Isotope Measuring Systems Inc.

1996 March 13

In response to your request we are pleased to provide the enclosed information concerning the mechanical design of the IMS Model 5321. The information includes some new drawings that were made specifically to meet your request for more information. None of the enclosed drawings are proprietary, as these drawings alone do not yield trade secrets. To the best of our knowledge this submittal should resolve the last of the outstanding issues regarding the IMS Model 5321 Device Registration. Please direct questions and commits regarding this matter to G. Burnet at IMS Inc.

IMS DRAWING 960312M
SOURCE SHUTTER BARREL
END STOP DIAGRAM

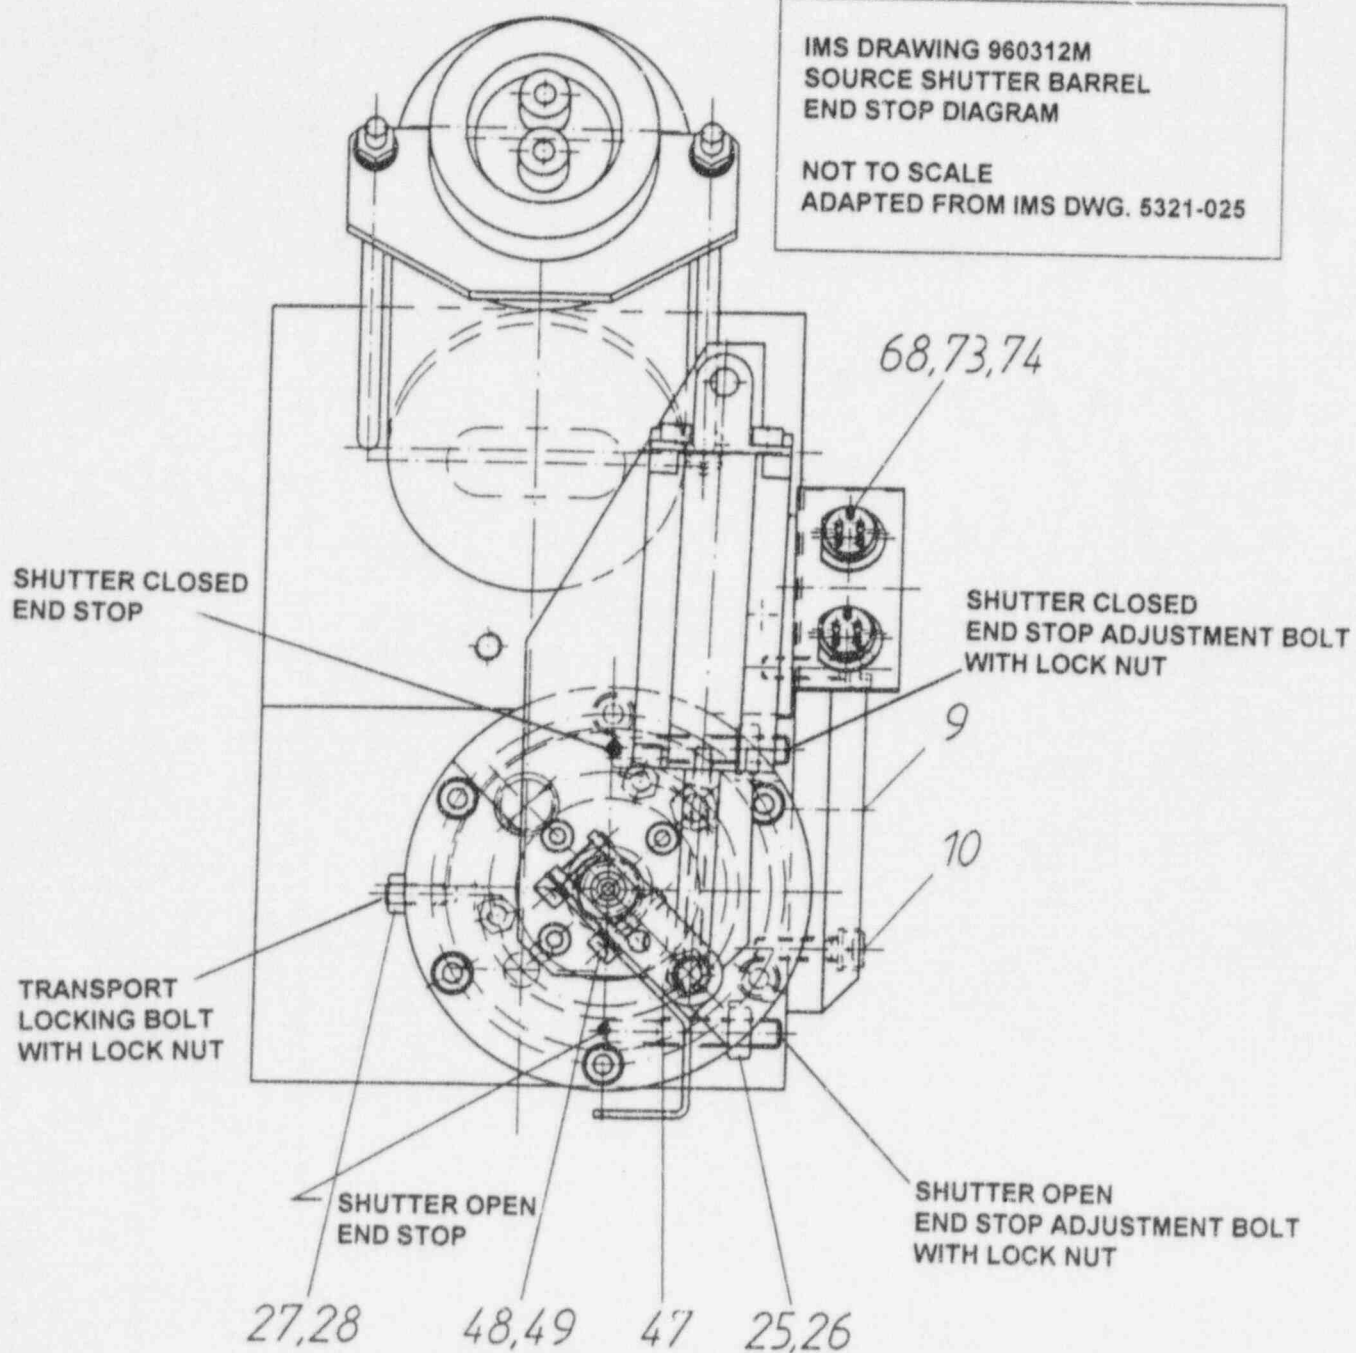
13. Source Shutter Barrel End Stops and End Stop Adjustments.

Please reference the modified enlargement of IMS Drawing 5321-025 labeled 960312M. This drawing shows the shutter end stops and their adjustment mechanisms. A modified copy of IMS Drawing 5321 - 025 - 14 indicating the end stop shoulders on the drive flange is enclosed for reference.

Maße ohne Tol.-Ang. n. D 7168 m	Maßstab 1:2 bei A4 Werkstoff Sinterwolfram S 18	
				Datum 28.08.95	Name Kleegräfe	Welle
				Gepr.		
				Norm		
				IMS		5321-022-07
Zust	Änderung	Datum	Name	ISOTOPEN-MESS-SYSTEME		Blatt Bl.

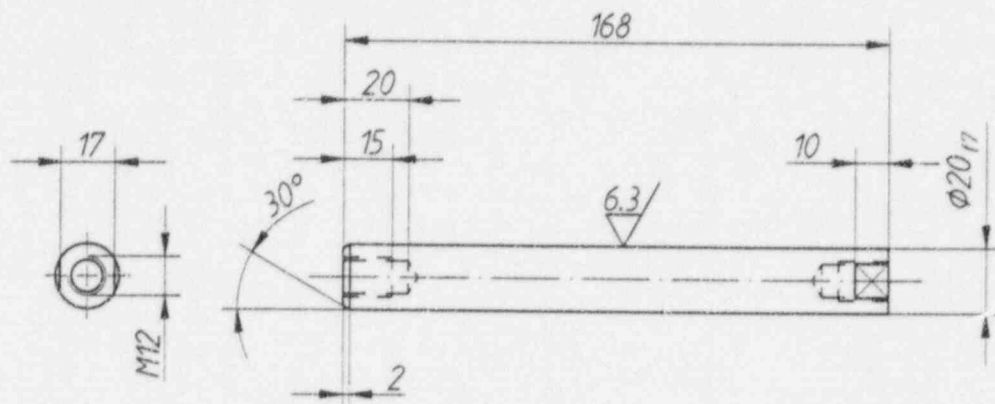
12. 5321-025-05 and 5321-025-06 Wellen (Shafts)

These shafts serve as mounting posts for the source holders. Their installation can be seen in the IMS Drawing 5321-022. The shafts themselves are detailed in IMS Drawings 5321-022-07/08.

DIN 9130/1307		Maßstab 1:1	
6.3		W.-Nr. 14301 oder gleichwertig	
Bearb.	Datum	Name	Welle
Gepr.	09.07.95	Rechner	
Norm			
5321-025-14		Blatt 1

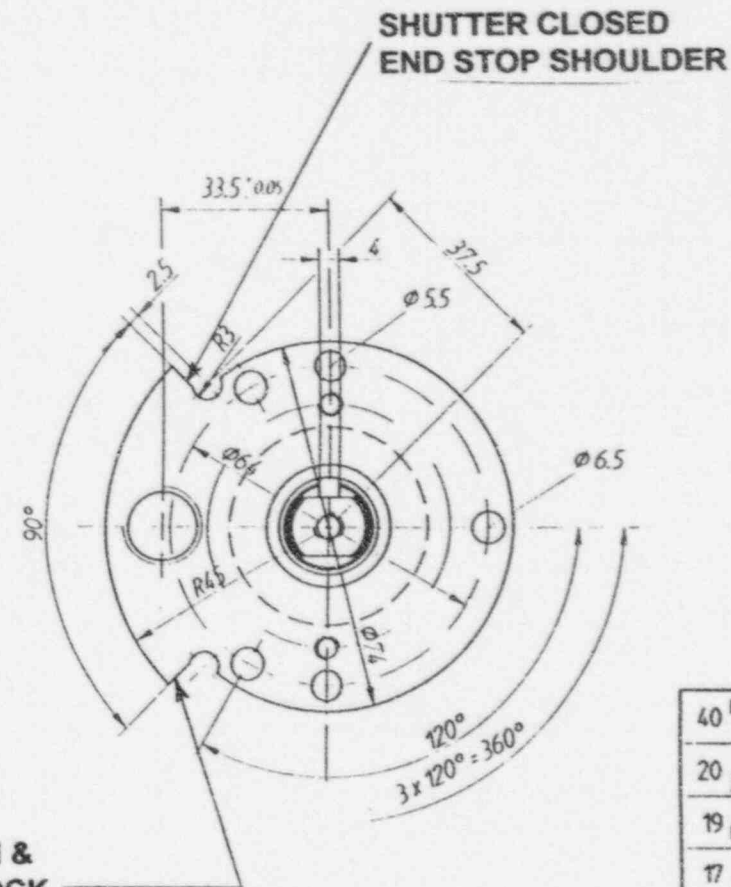
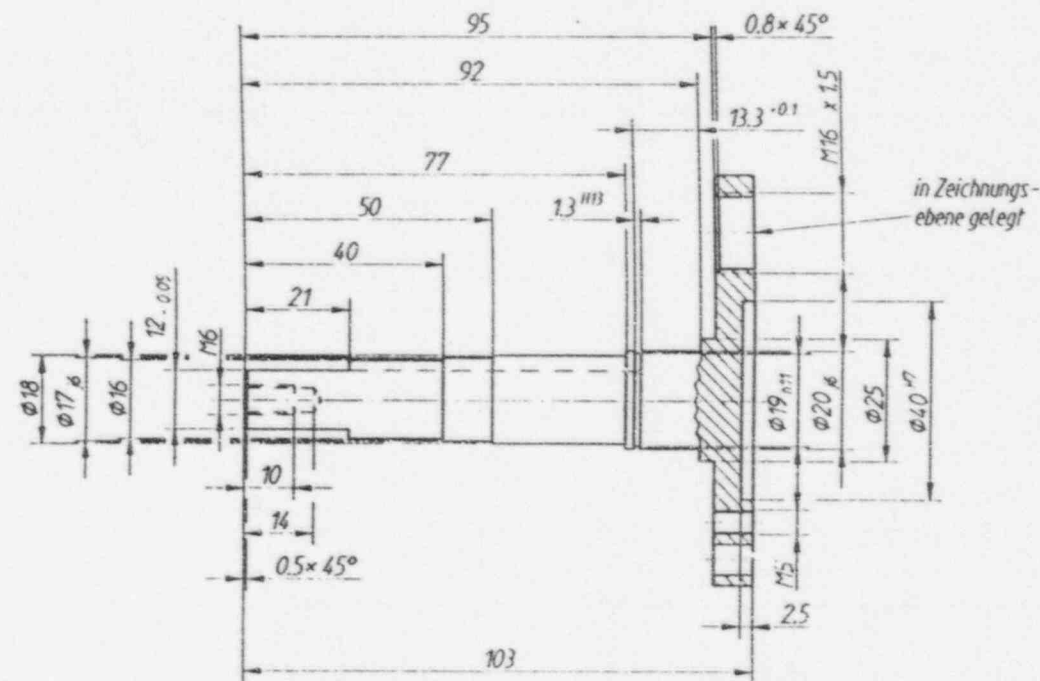
The shutter barrel is pinned to the drive flange. The two pins are shown on IMS Drawing 5321-025 M1. The pins do not appear on drawing 5321-025-02 because this is a manufacturing drawing. The holes for the pins are bored after the flange is mounted, so there will be perfect alignment of the pin holes between the flange and the barrel. The 5.5 mm diameter pin holes can be seen on IMS drawing 5321-025-14 (enclosed for reference)

SHUTTER OPEN &
TRANSPORT LOCK
SHOULDER

MODIFIED 1996 MARCH 13
FOR ILLUSTRATIVE PURPOSES

Obfl. Rt. ISO 1302	Maße ohne Tol.-Ang. n. D 7168 m	Maßstab 1:1 bei A4	
				6.3		Werkstoff	W.-Nr. 1.4301 oder gleichwertig
				Datum	Name	Scheibe	
			Bearb.	13.02.95	Baumann		
			Gepr.				
			Norm				
						5321-025-19	Blatt
Zust.	Änderung	Datum	Name			ISOTOPEN-MESS-SYSTEME	BL.

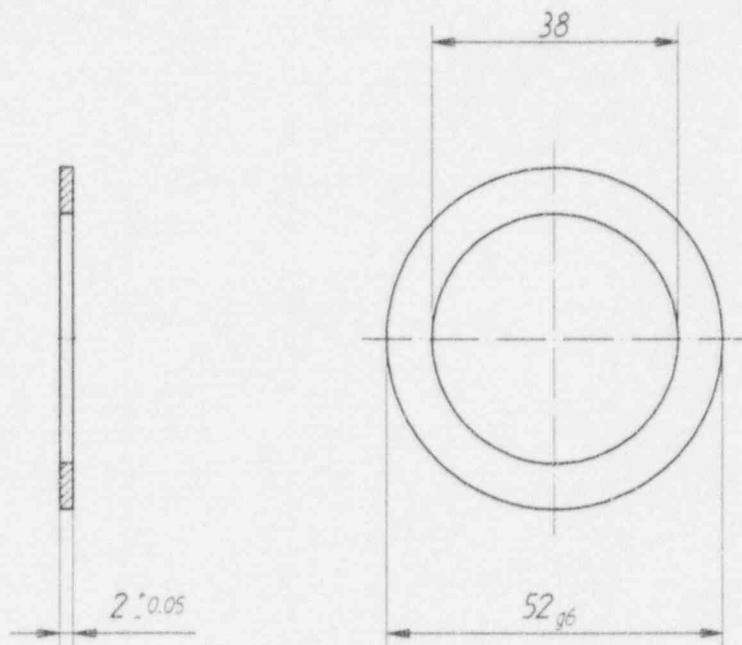
8. 5321-025 Blatt 1, Positions 30,31,36

The Scheibe (Position 31) is described in IMS Drawing 5321-025-19 (enclosed).
